# CITY OF NEW BEDFORD

## COMBINED STAFF REPORT

**Case #2019.26 CERTIFICATE OF APPROPRIATENESS (Mod.)**

**Case # 19-36: SITE PLAN REVIEW (Mod.)**

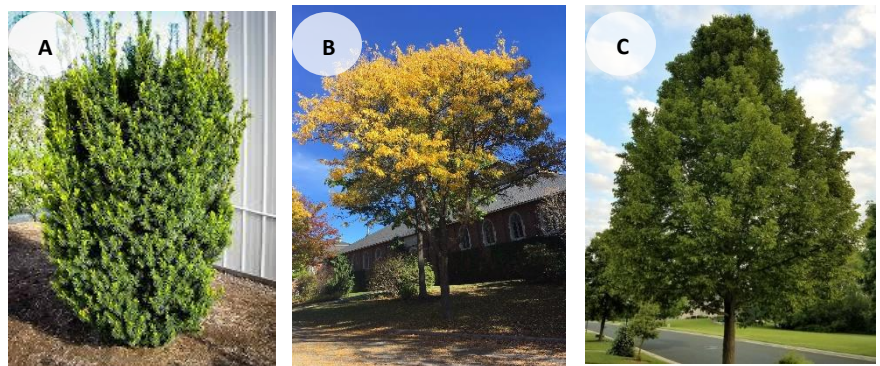
Entrances for 117 Union Street include; two doors on Union Street; one providing direct access to a stairwell to the upstairs residential units, the second providing general access to the first-floor commercial/café space. One door on North Front Street providing access to a lobby area. There is access via two doors on Barkers Lane one is direct access into the first floor resident lobby; while the second is a shared entryway that connects all three buildings and provides access to the bicycle storage room, trash room, the first floor resident lobby, and the rear entrance to the Moby Dick Building. A door previously shown as access to a fire service equipment room has been removed on the northwest corner of the building.

Entrances for the Moby Dick Building include; two doors on Union Street; one providing direct access to a stairwell to the upstairs residential units, the second providing general access to the first-floor commercial/restaurant space. Access to the rear of the building is provided via a shared entry vestibule that connects the Moby Dick Building to the other two buildings.

Existing - 5 Lots

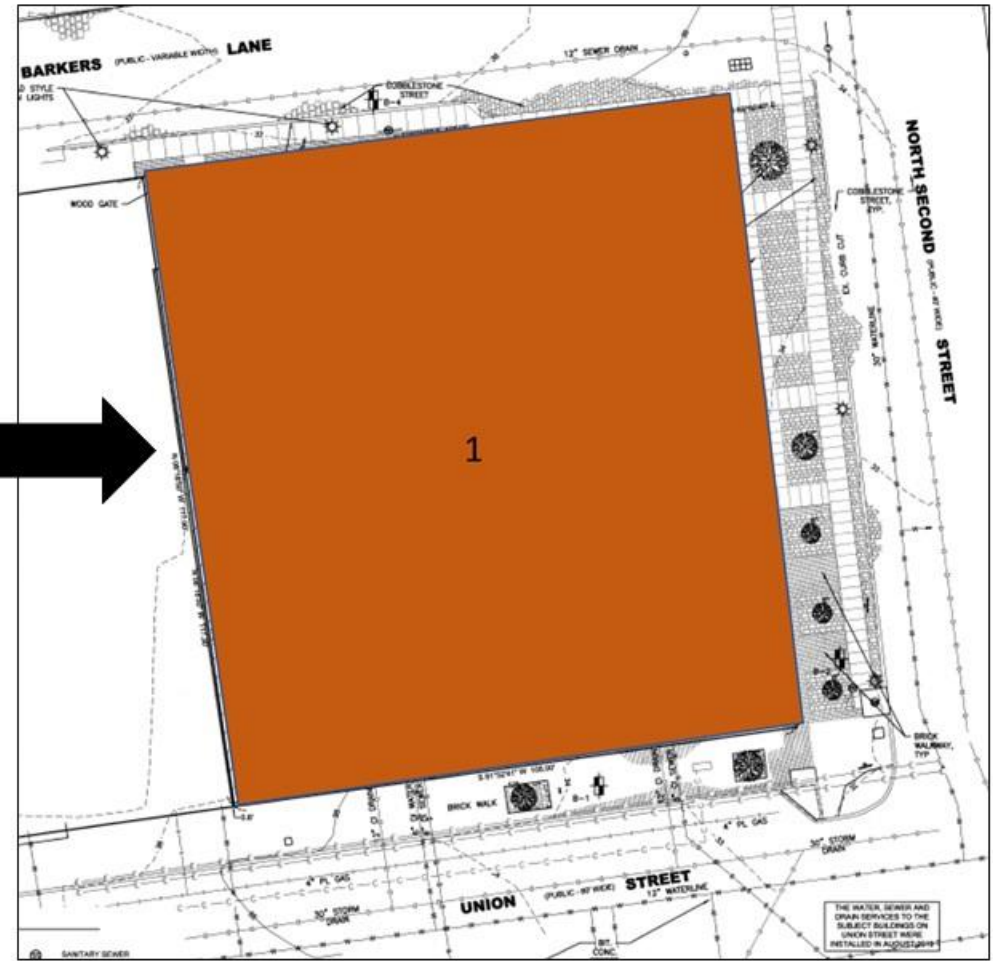
The applicant intends to combine and subdivide the existing lots into two lots through the Approval Not Required (ANR) process. The ANR process is a defined process in Massachusetts General Law that allows for property lines to be adjusted/subdivided without a full subdivision review, if the lots meet certain criteria, namely adequate frontage on a roadway. There is a 21 day window to grant ANR approval.

As proposed the lots will be divided such that one lot will have just the three-story Moby Dick Building and the second will be a “L-Shaped” lot comprised of the land area intended for the 117 Union project with parking space. The proposed lots are shown as Lot 1 and Lot 2 on Sheet C-1 of the plan set.

Due to several complex zoning code issues that arise from the proposed subdivision of the land, the applicant has agreed to extend the time limits for ANR approval in order to seek the appropriate permits and required relief.

Notably, the applicant will seek multiple variances from the Zoning Board of Appeals for dimensional requirements. They will also be required to receive a variance for parking on the Moby Dick lot.
